## 167 (GLE) - Rearview Camera Noise Optimization

Topic number	LI54.71-P-080180
Version	5
Function group	54.71 - Camera and radar-assisted assistance systems
Date	3/24/26
Validity	167 Facelift (GLE) with the following:  - Model Year 2024 and later (Option code 804, 805, or 806)  - Option Code 491 (Steel Spring Variant)  - Option Code 235 (PARKTRONIC with Active Parking Assist)
Reason for change	Updating language.

View PRIOR to SCN Coding:

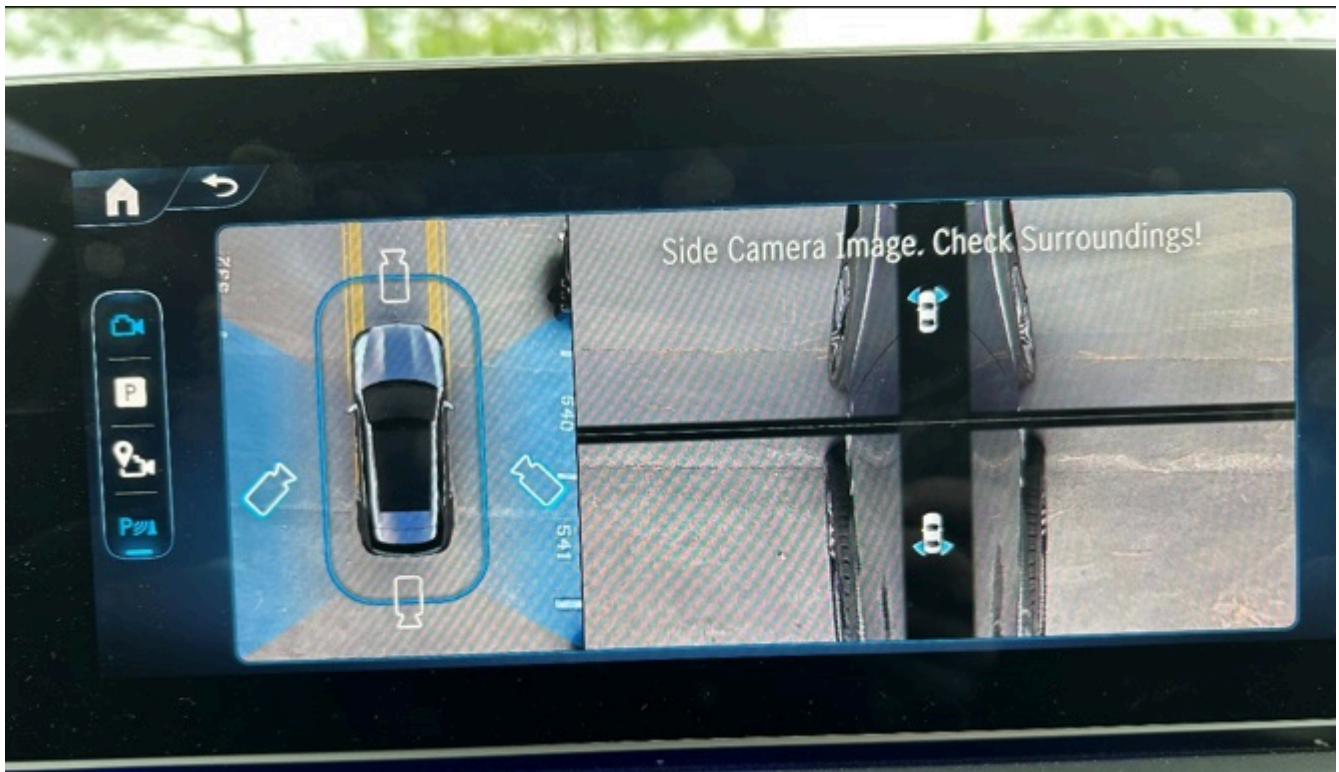
**IMPORTANT:** After both control units have been SCN coded, the "Movable 3D View" feature in the head unit will no longer be available. With this change there will be two distinct differences:

- 1) The "3D" icon when in the top down vehicle view, will no longer be present on the head unit.
- 2) The digital rendering of the vehicle with the ability to spatially move around the vehicle is no longer possible. This view is replaced with 2D static images of the left and right sides.

- Rear camera flap when calibrating after a key cycle bus sleep will stay open to 29 MPH and then close. Will re-open, when calibrating, at 9 MPH.
- The head unit screens mentioned above appear the same as "View AFTER SCN Coding" as shown in the attachment.
